Accessibility Review Report – DA Review

Project Title: Northside Gosford Private Hospital
Corner Racecourse Road & Faunce Street, Gosford

Date: 22 July 2020

Report Version: 9030_ADR_DA_v2.0

Figure 1 – Ground Floor Plan Mark-up

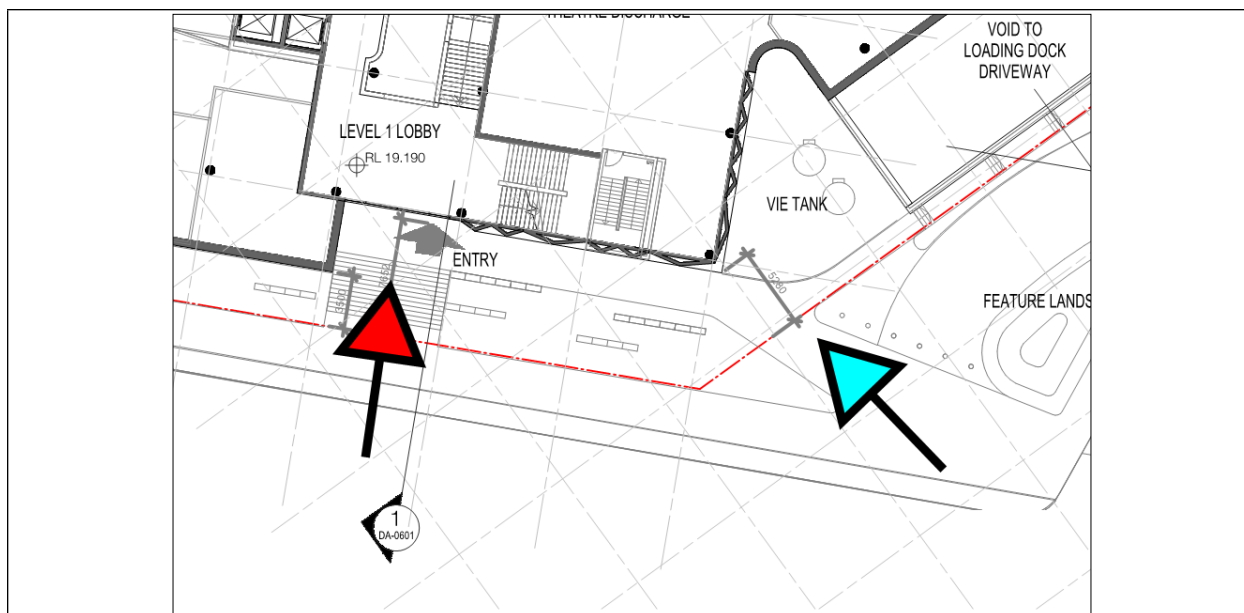
DtS Provision	Comment(s)/Recommendation(s)	Status
An accessway must be provided to a building required to be accessible – - from the main points of pedestrian entry at the allotment boundary; and - from another accessible building connected by a pedestrian link; and - from any required accessible carparking space on the allotment. In a building required to be accessible, an accessway must be provided through the principal pedestrian entrance, and – - through not less than 50% of all pedestrian entrances including the principal pedestrian entrance; and - in a building with a floor area more than 500m², a pedestrian entrance which is not accessible must not be located more than 50m from an accessible pedestrian entrance. except for pedestrian entrances serving only areas exempted by D3.4.	Accessways From Allotment Boundary Figures 1 & 2 below indicate the pedestrian entrances at the allotment boundary. - Blue arrow indicates an accessible accessway. - Red arrow indicates a non-accessible accessway. BCA Clause D3.2(a) requires an accessway to be provided from the main points of pedestrian entrance at the allotment boundary. <u>Performance Solution & Detail Design –</u> Due to the distance between the stairway and accessible entrance the following pedestrian pathways are considered to be a compliance departure: Ground Floor: 	DD & PS

Level 1:
